**SELMON
EXPRESSWAY**

Whiting Street PD&E Study

Pond Siting Report

THEA Project No: HI-0112

WHITING STREET PD&E STUDY EXISTING DRAINAGE MAP

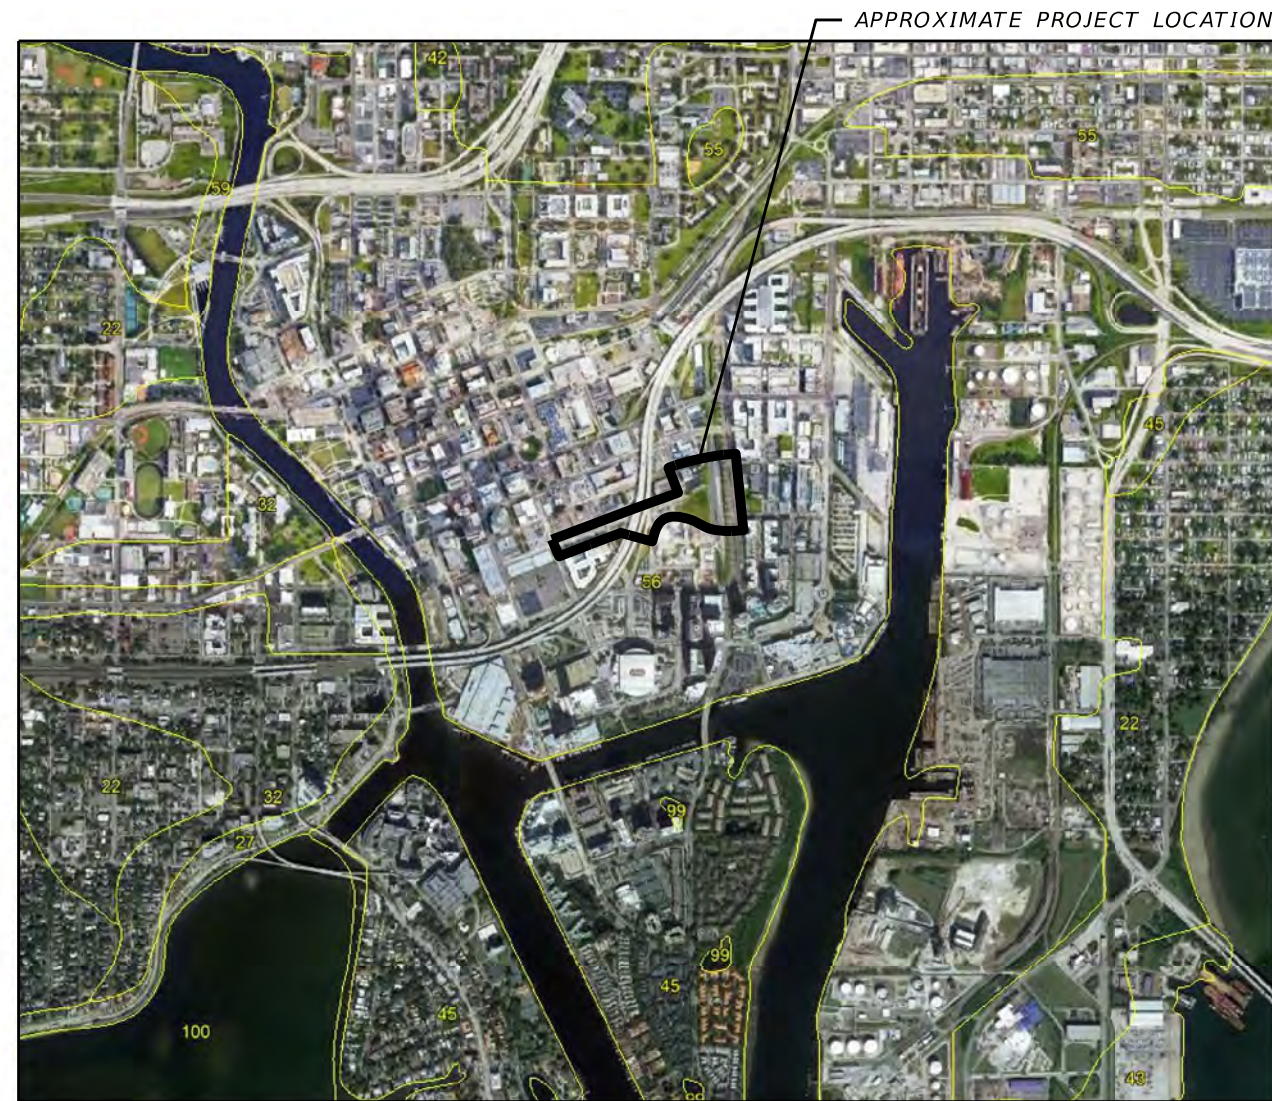
Follow-up Comment: Response accepted.
16. PDF Page 37 of 69: The brownish lines blend into the Aerial and should be changed to a different color. What do these lines depict? It appears that flow arrows are there (green) but that the scale provided the flow arrows cannot be read. Please provide larger flow arrows or, as an alternative, include flow arrows on the Pond exhibits later in the document.

Response: The drainage map will be revised for clarity. Flow arrows will be enlarged.

BORING LOCATION PLAN

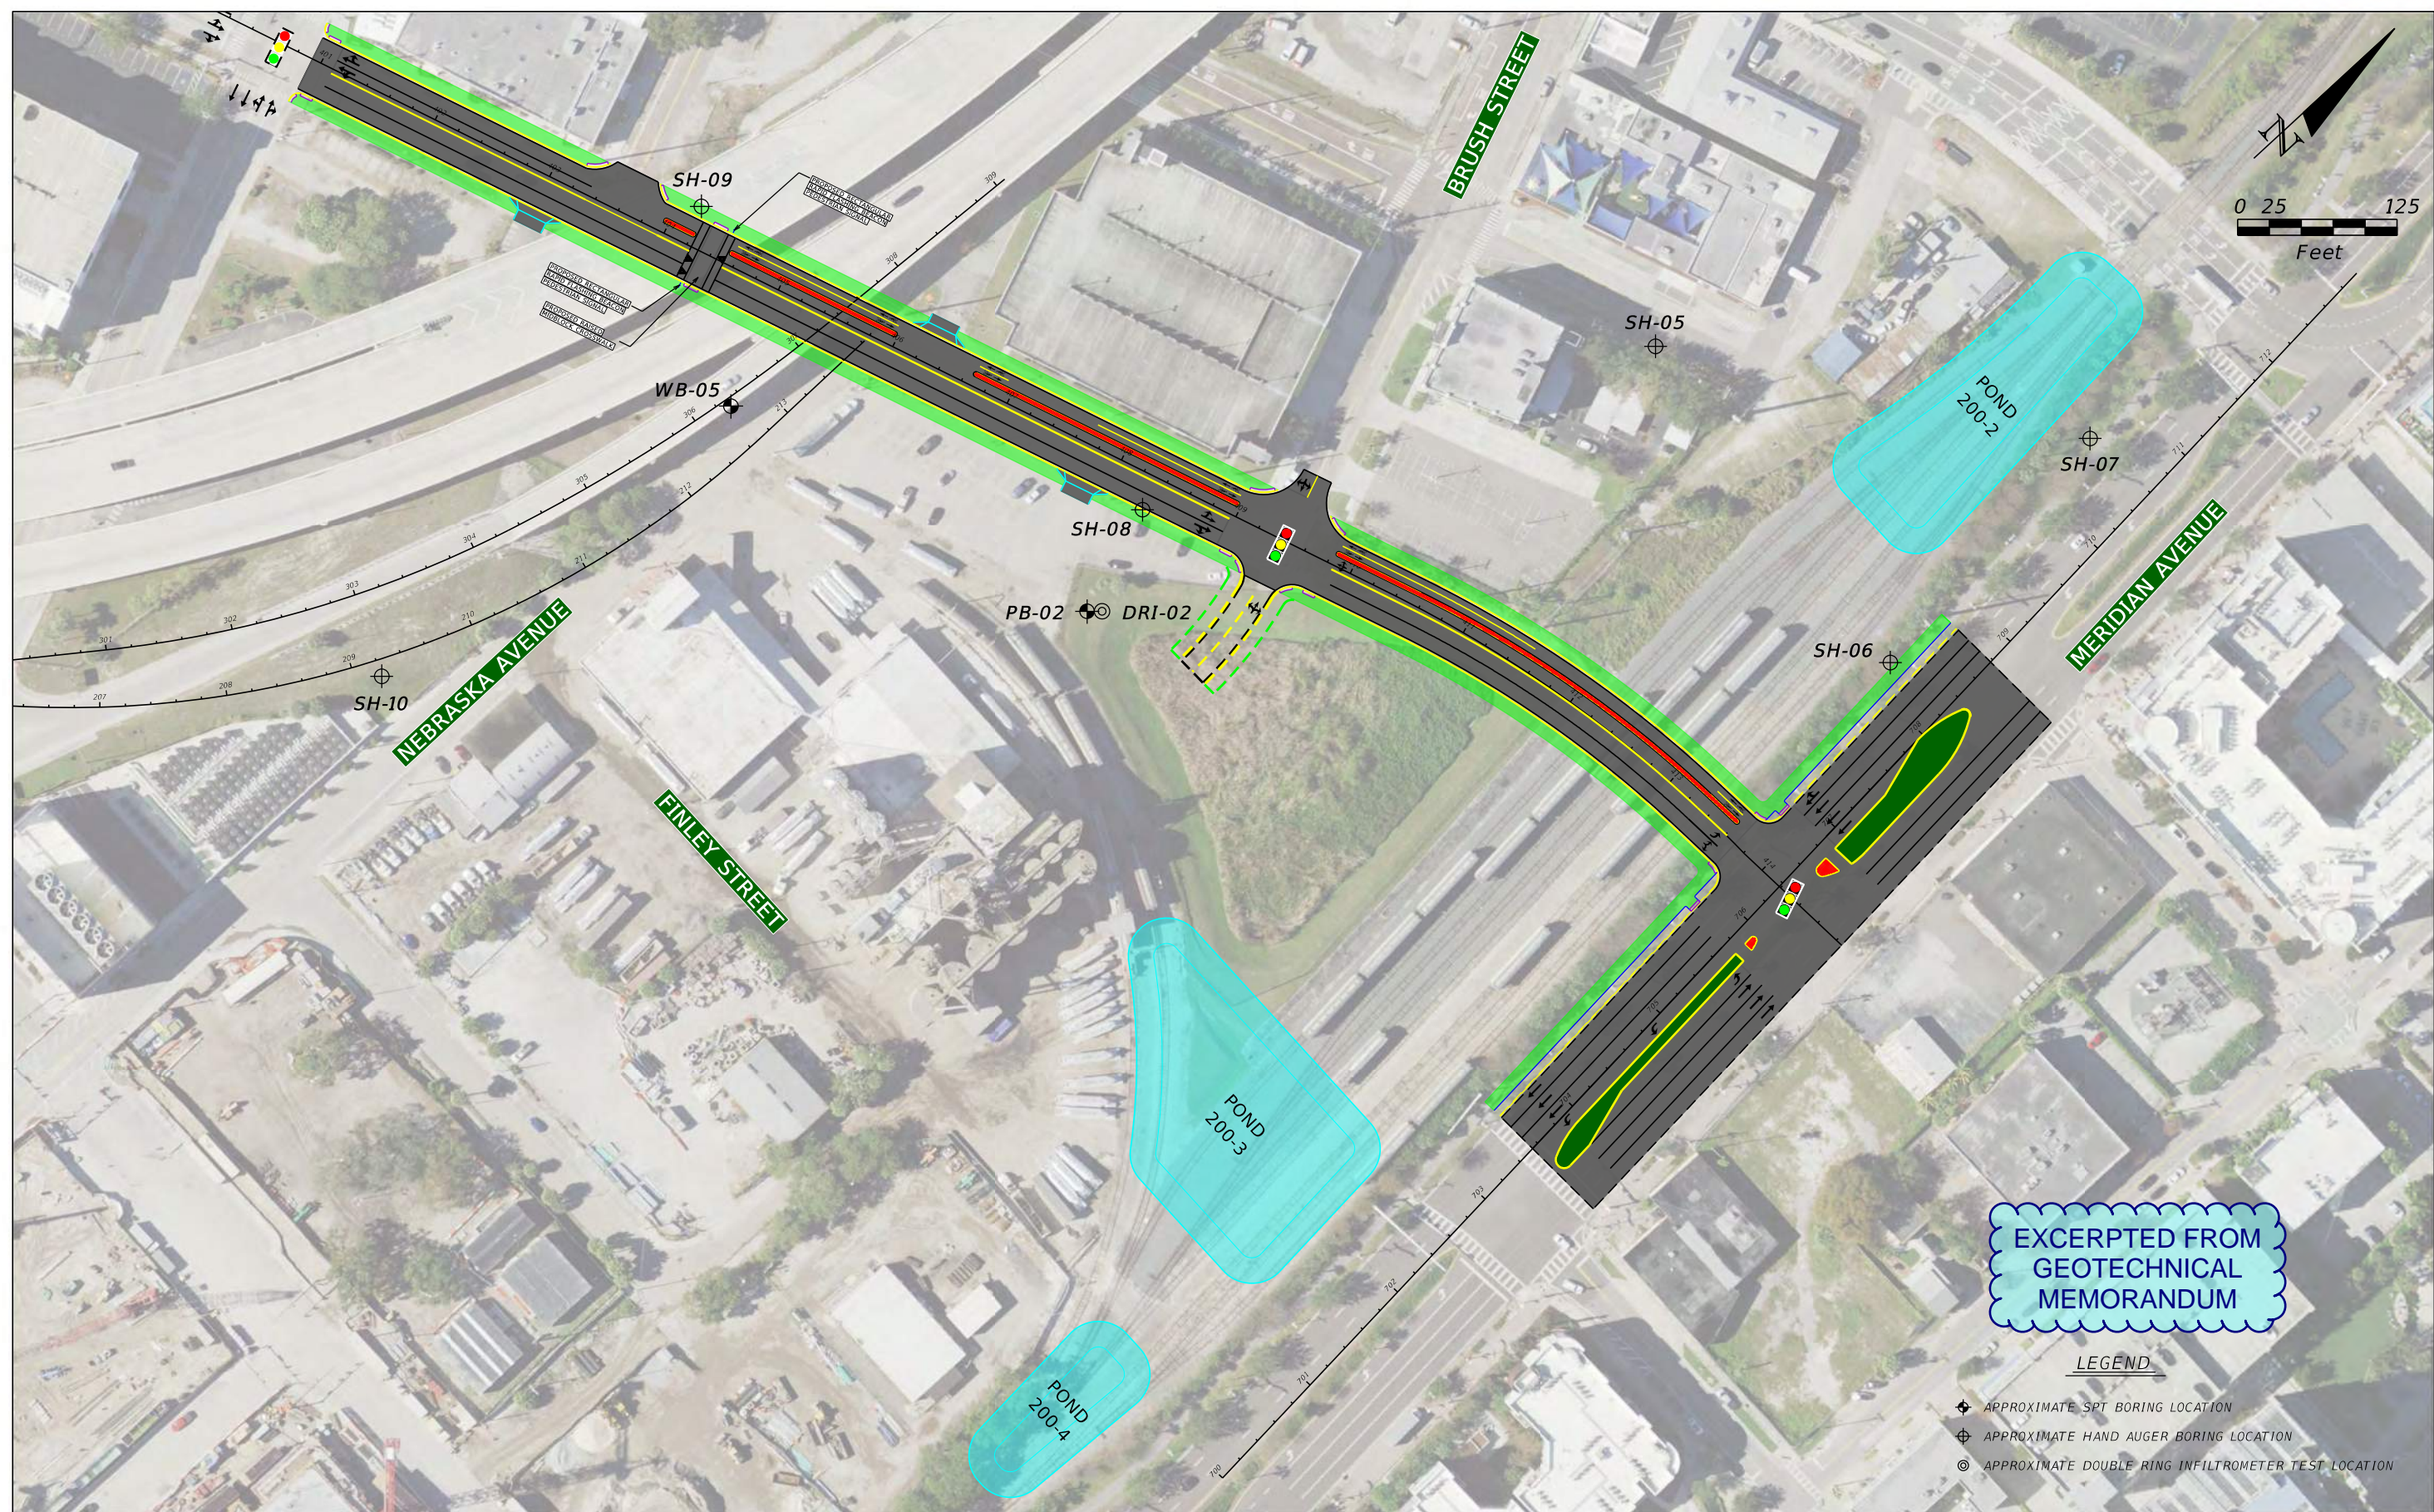
Follow-up Comment: Response accepted.
17. Sheet 42 of 69: Pond 200-1 and Pond 200-2 are depicted differently here than they are in subsequent exhibits. Please reconcile.

Response: The Boring Location Plan is an excerpt from the Geotechnical Memorandum. It has been revised to correspond to the latest alternative pond sites.
